Access Compliance Report Public Rights-of-Way (Curb Ramps)

Main Street: IRVINE_BLVD Cross Street: RANCHWOOD_RD Location: NE

ADA ID: RPRK211006112956 Ramp Type: Type 1 - Perpendicular Diagonal Initial Pass/Fail: Pass Overall Compliance: No Severity Score: 15

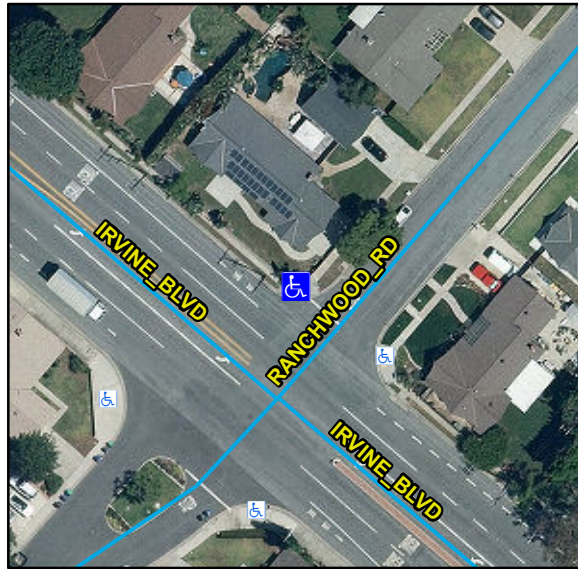
Compliance	Description	Data	Compliance	Description	Data
N/A	Ramp Length (in)	96	N/A	Flare Type LT	
Yes	Ramp Width (in)	48			Sloped
Yes	Ramp Run Slope (%)	6.9	N/A	Flare Slope LT (%)	6.3
Yes	Ramp Cross Slope (%)	1.5	N/A	Flare Traversable LT	No
N/A	Landing Present	No	N/A	Flare Type RT	
N/A	Landing Length (in)	N/A			Sloped
No	Landing Width (in)	N/A	N/A	Flare Slope RT (%)	11.5
No	Landing Run Slope (%)	N/A	N/A	Flare Traversable RT	No
No	Landing Cross Slope (%)	N/A	Yes	DWS Provided	Yes
N/A	Landing Movement Obstructed?	Yes	Yes	DWS Contrast	Yes
	Landing Movement Type	Curb	Yes	DWS Length (in)	36
N/A	Landing Shared	N/A	Yes	DWS Full Width	Yes
N/A	Clear Space	Yes	Yes	DWS Offset Left (in)	0
N/A	Clear Space To Crosswalk (in)	48	Yes	DWS Offset Right (in)	N/A
N/A	Marked Crosswalk 1	No	N/A	Marked Crosswalk 2	No
	Crossing 1 Direction	W		Crossing 2 Direction	S
	Marked Crosswalk 1 Width (in)	N/A		Marked Crosswalk 2 Width (in)	N/A

N/A	Ramp Inside Crosswalk 1	N/A	Yes	Ramp Inside Crosswalk 2	N/A
	Crossing 1 Slope (%)	14		Crossing 2 Slope (%)	0.7
	Crossing 1 Cross Slope (%)	0.7		Crossing 2 Cross Slope (%)	1.2
Yes	Gutter Ponding	No	No	Curb Slope	10.3
Yes	Gutter Lip Height (in)	0		Road Run Slope (%)	1.1
No	Gutter Run Slope (%)	6.1		Road Cross Slope (%)	1.1
Yes	Gutter Cross Slope (%)	0.9			
Yes	Overall Surface Condition: Acceptable		No	Perp Joint Present	No
	Cross Gutter Present?	No		Spandrel Present?	No
	Replace Cross Gutter?	N/A		Replace Spandrel?	N/A

Remove & Replace Curb Ramp With Two New Directional Ramps or Equivalent. Remove & Replace Gutter.
